## **OICA comments on document GRSP/2006/7 presented by the USA**

### **OICA comments on ECE/TRANS/WP29/GRSP/2006/7**

Example of "high front vehicle"

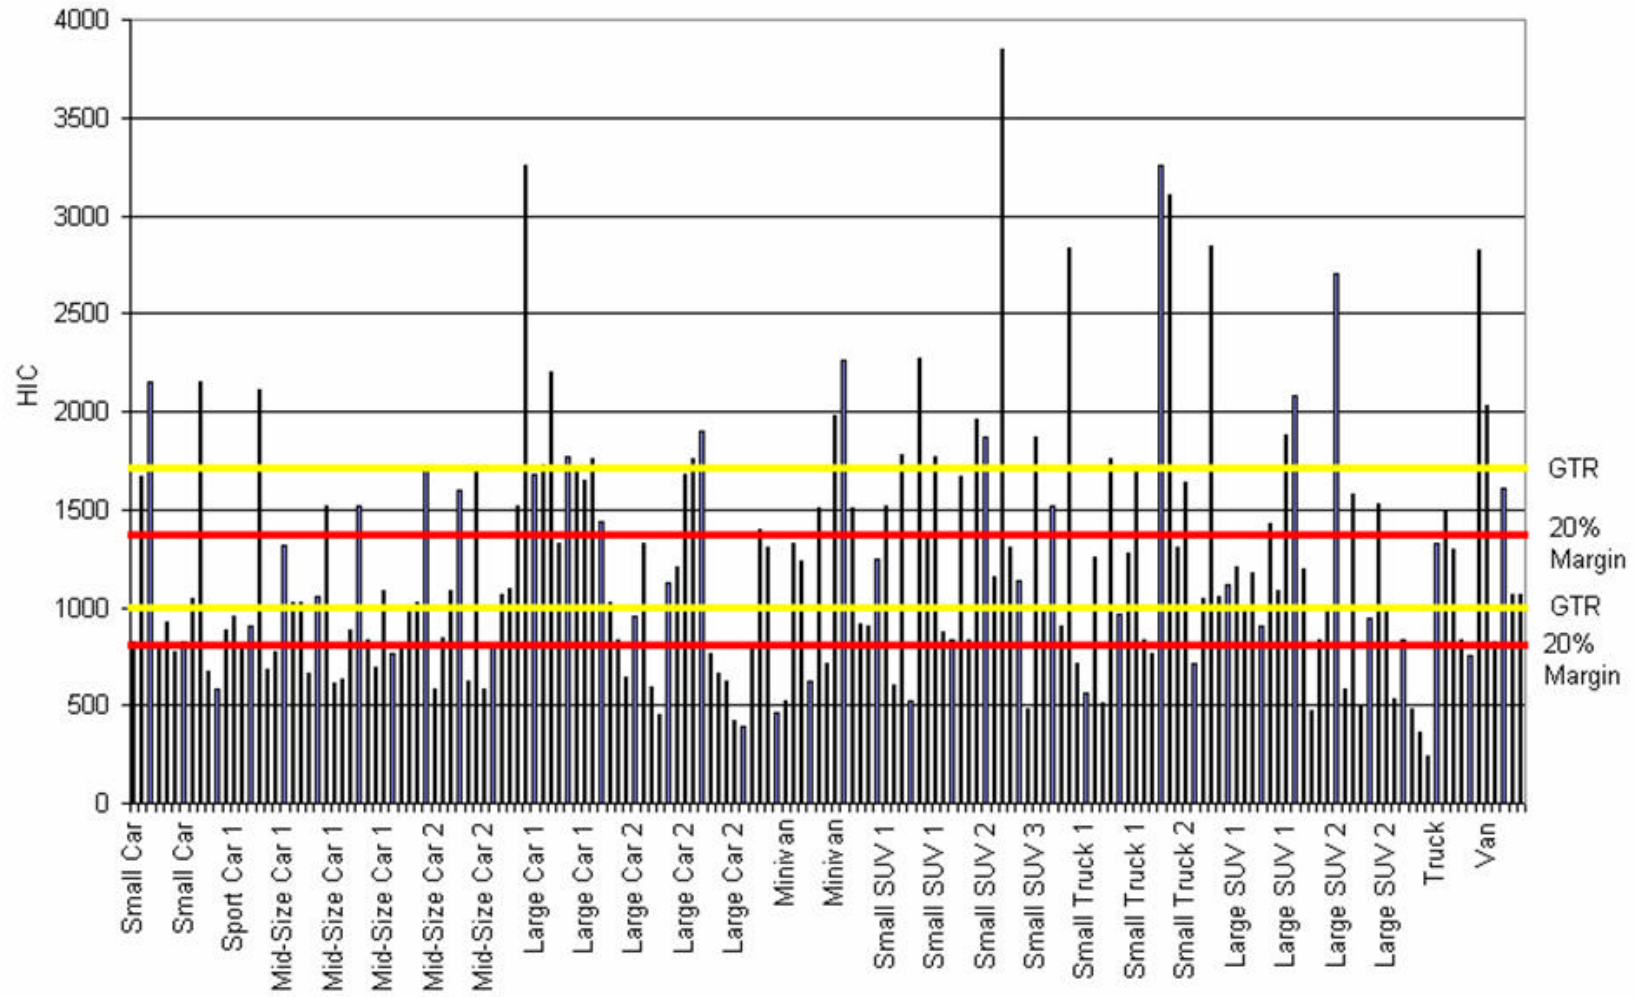
Finally, many "high front" vehicles, where the bonnet leading edge is rearward of the 1000 mm wrap-around line, would fall in the category of vehicles above 2.5t GVW. An example of such vehicles is shown in Annex 1. Such high front vehicles clearly would have extremely severe difficulties to meet the proposed requirements and no technical solution is known at this time. As a matter of fact, such vehicles were never considered in detail during the development of the proposed gtr and it is in addition very doubtful that the accident scenarios (pedestrian kinematics and injuries), as validated for "classical" passenger cars, would be the same for these high front vehicles.

### GTR Feasibility - Alliance Head Test Results

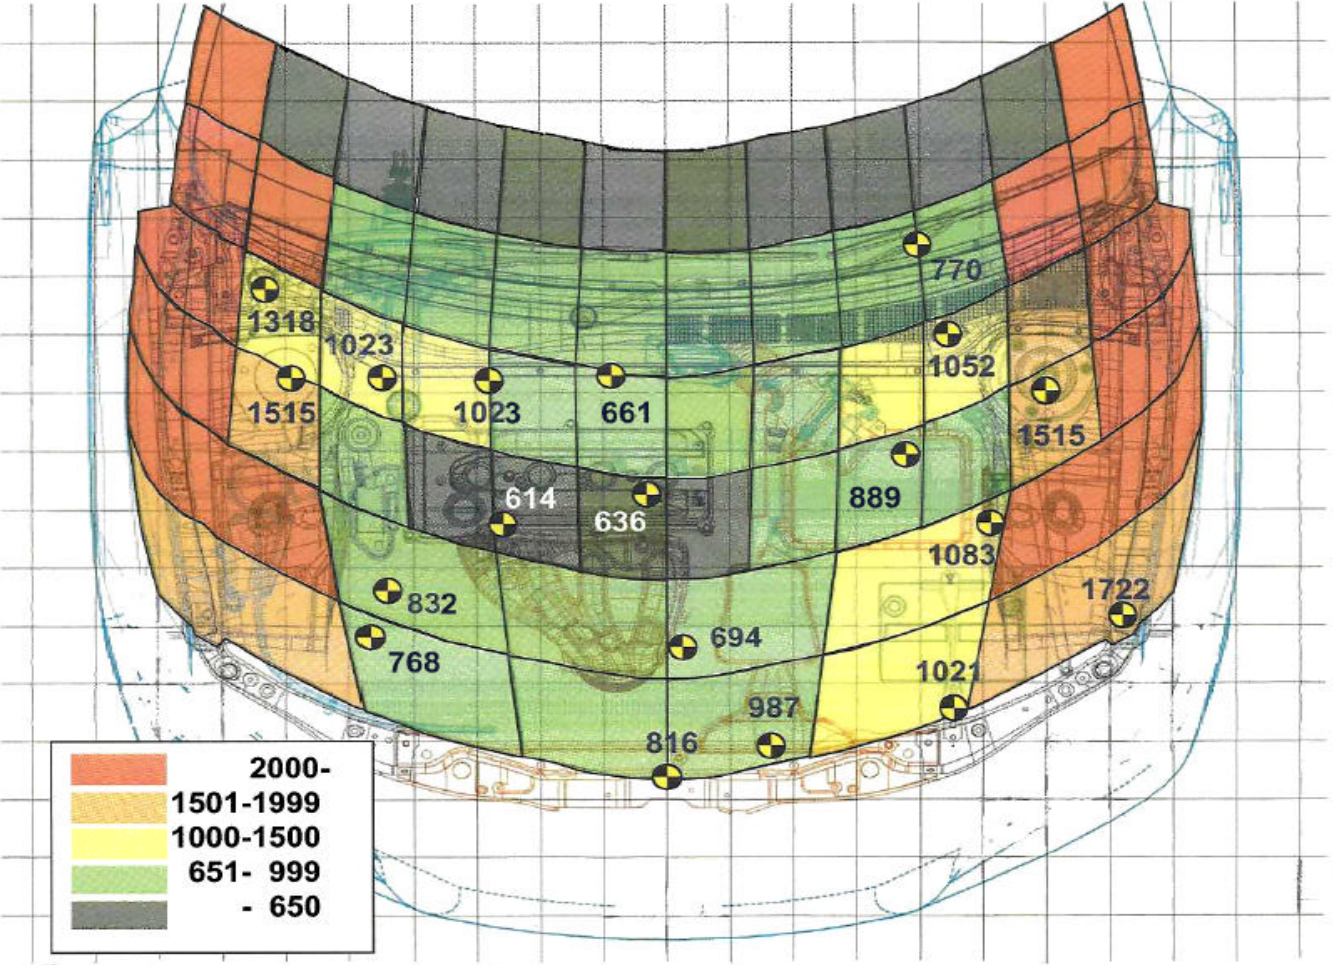
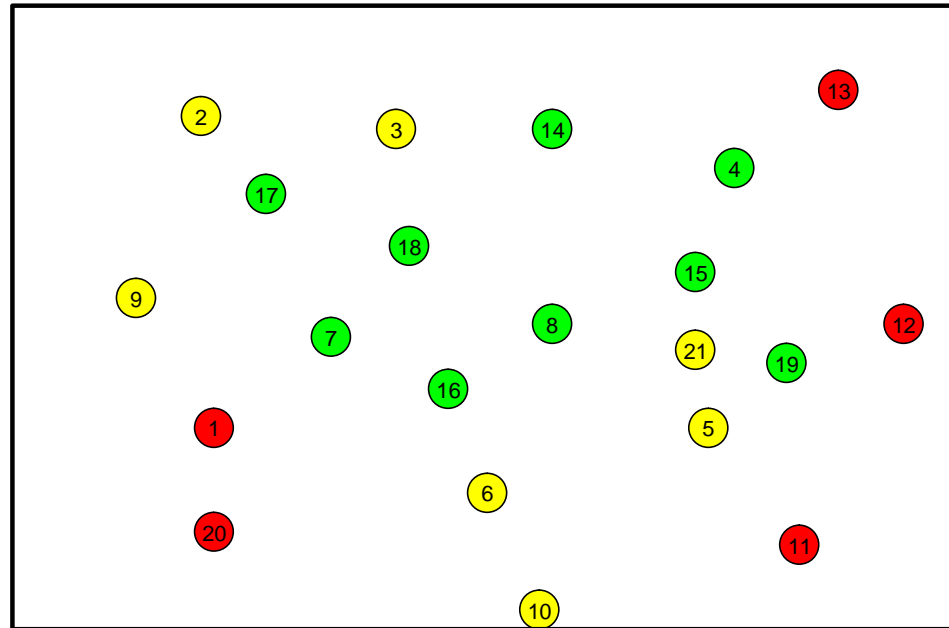
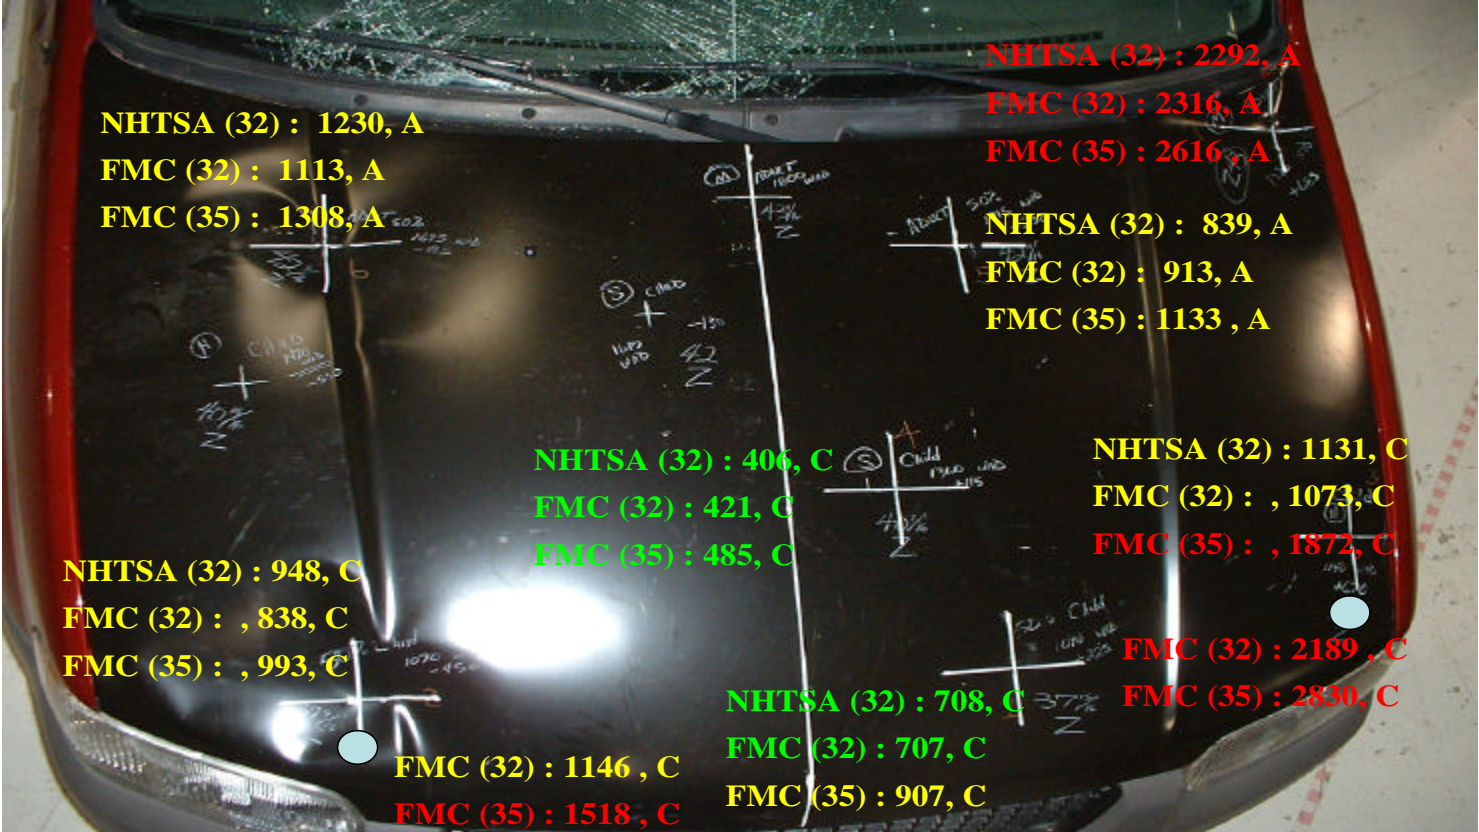
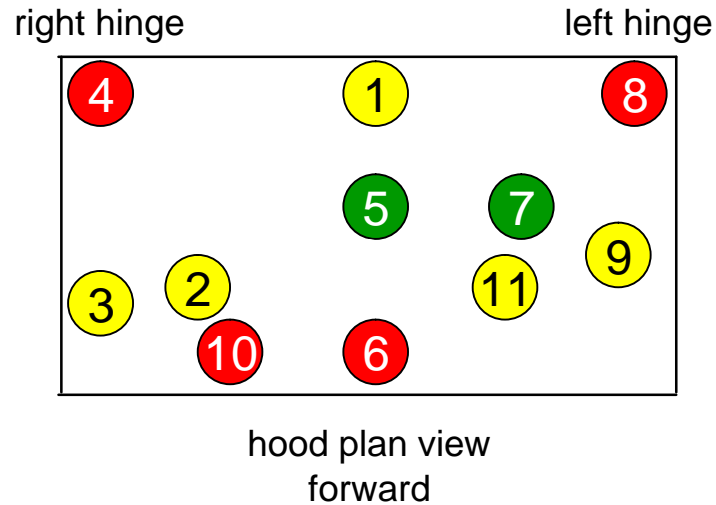
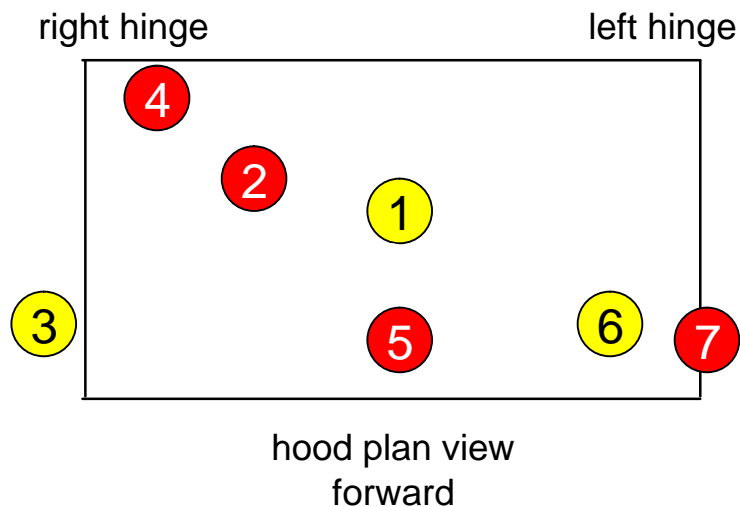
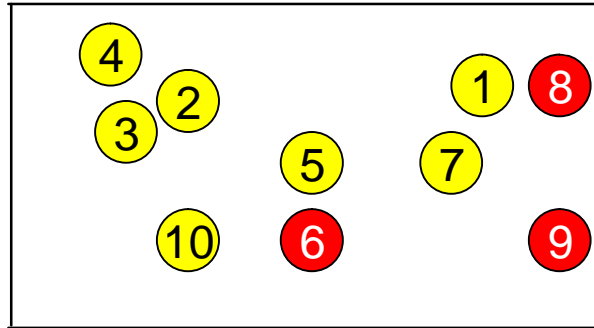
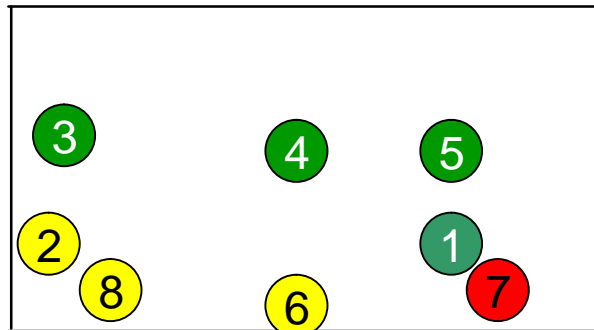
In addition, new data have recently been received from the Alliance of Automobile Manufacturers in the US. These data are attached in Annex 2. The tests were performed exactly in accordance with the draft gtr specifications and show that a large portion, approximately 19%, of the impacts resulted in HIC values above 1700 and only 44% below 1000. Additionally if considering a 20% compliance margin, necessary in any certification scheme, approximately 32% of the tested impacts result in HIC above 1360 (20% below the HIC 1700 limit) and only 27% below 800.

It is also interesting to note that the attached data also indicate that the test conditions of the draft gtr are up to 65% more severe than those used by the US to justify the proposal in GRSP/2006/7.
